Safety Defect and Noncompliance Report for PART 573 Defect and Noncompliance Report³

The parts in question are two separate aftermarket ball joints sold as four part numbers in the marketplace – D10945, D10946, G10945, and G10946. The parts fit the below OE applications but were never installed as Original Equipment. These are replacement parts only for the equivalent OE parts and are sold by Qualis Automotive to a limited customer base. These customers are described as aftermarket parts distributors and retailers.

The G10945 and G10946 are the same part as the D10945 and D10946 respectively, just labeled differently depending on the aftermarket customer.

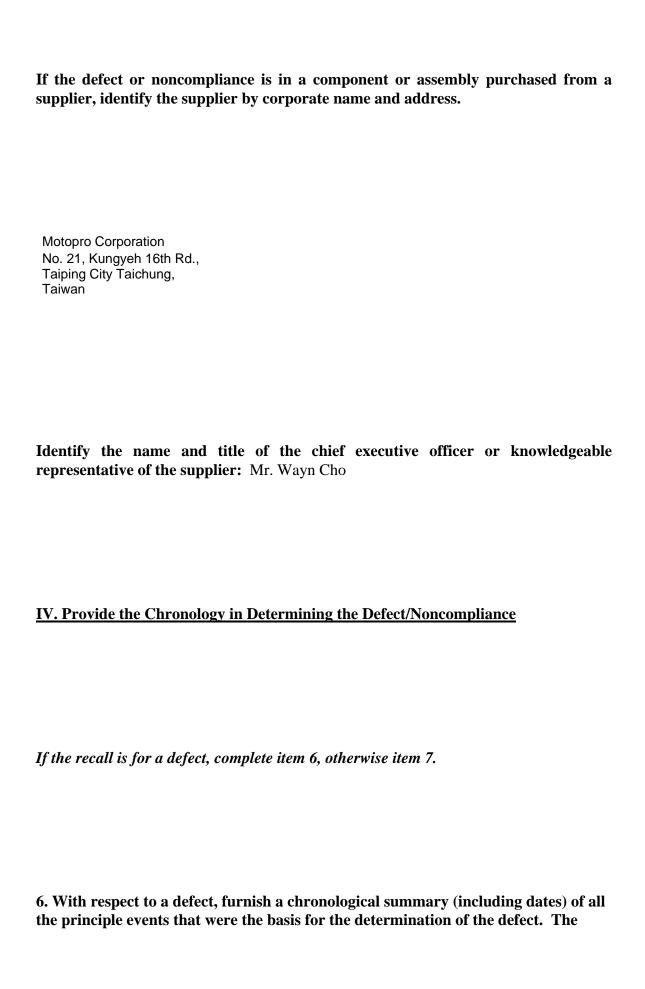
The defect occurs in the front chassis/corner module area, specifically the control arm with ball joint and its connection with the hub or spindle area. The ball stud may separate from the socket of the ball joint housing on the lower control arm. Both left and right side could be affected by this issue.

The housing separated as a result of the case hardness being too deep. The hardness numbers (measured by the manufacturer Motorpro) indicate the case was through hardened. At the hardness range measured and depth, the material became brittle and could not withstand an impact load. The retaining ring groove located in the area of the induction hardened zone had sharp corners which was a probable place for a crack in the case to propagate to and separate when an impact load was applied to the ball joint.

When the ball stud separates from the socket of the ball joint housing of the lower control arm it results in the separation of the lower control arm to the spindle. Potentially allowing the wheel to fold and could cause the loss of steering ability. The two reported incidents had minimal damage.

8. Furnish a description of the manufacturer's remedy for the defect or noncompliance. Clearly describe the differences between the recall condition and the remedy. The original design of the ball joint had a retaining ring groove on the OD of the housing and the induction hardness specification only stated a minimum requirement. The new ball joint design no longer has the retaining ring groove and the induction hardness specifications were added to the drawing with both upper and lower limits. The limits to the induction hardness will eliminate the over hardening of the ball joint.

Clearly describe the distinguishing characteristics of the remedy component/assembly versus the recalled component/assembly. The only visual difference that will be seen between the old design and the new design is the absence of the retaining ring groove. This can only be seen if the rubber boot on the ball joint is removed.
